**From:** Scala, Mary Joy  
**Sent:** Tuesday, August 16, 2011 1:21 PM  
**To:** kayhumes@comcast.net  
**Subject:** BAR Actions July 19, 2011

**RE: Certificate of Appropriateness Application**

BAR 11-07-01  
423 2<sup>nd</sup> Street NE  
Tax Map 33 Parcel 86  
Kay Humes, Applicant and Owner  
Restore exterior; Remove chimney

**CITY OF CHARLOTTESVILLE  
BOARD OF ARCHITECTURAL REVIEW  
STAFF REPORT  
July 19, 2011**

EXT. FRONT ELEVATION

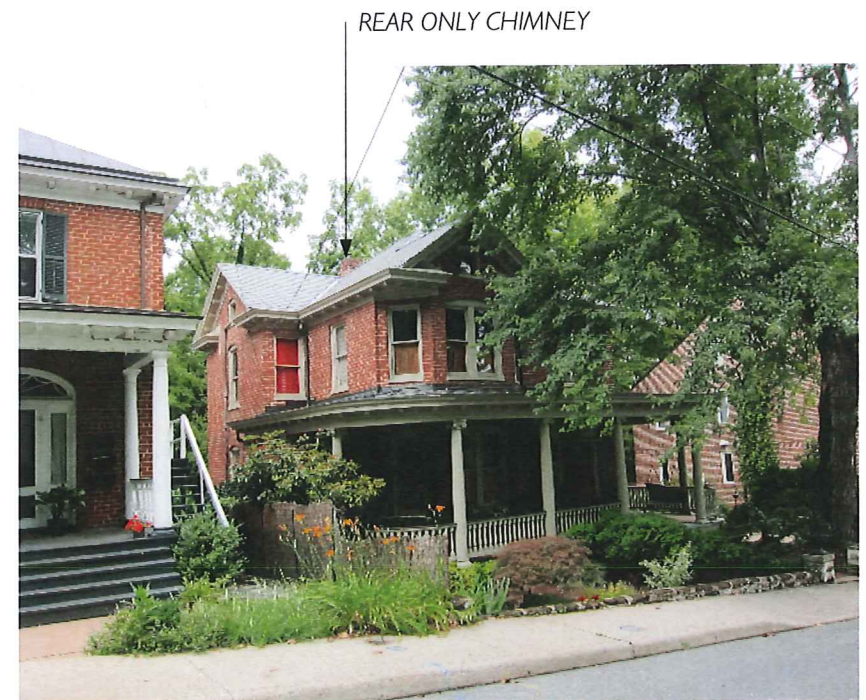
The BAR must determine if the front chimney contributes to the style and character of the building.

Any replacement work, such as the front steps, should match existing materials and design.

The BAR may wish to see more detail on the porch lighting, proposed landscape plan, etc.

**Approved (6-0-1 with DeLoach recused) application as submitted (remove front chimney, porch gutter, north door & stairway, add shutters, exterior repairs & site work). If the handrail design changes, it should come back to the staff for approval.**

EXISTING REAR ELEVATION

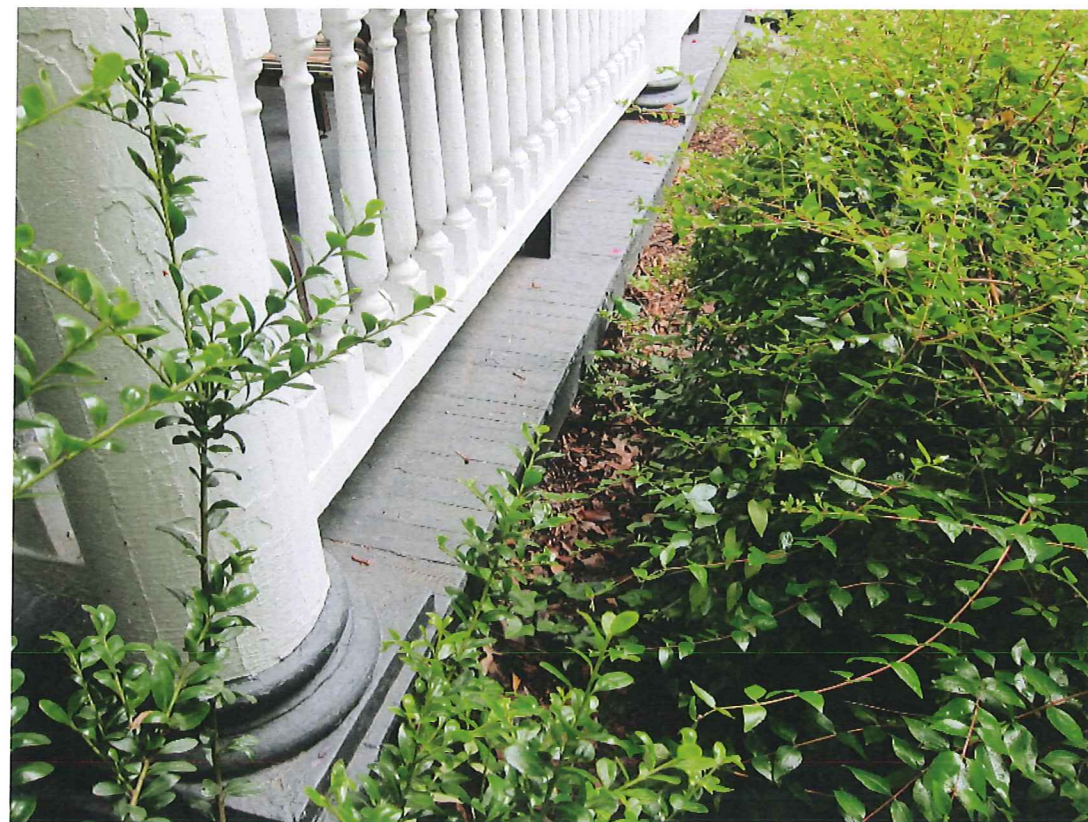
The shutters should match the existing style, should be hung, and sized to fit the window. The material should be wood or a BAR-approved composite.
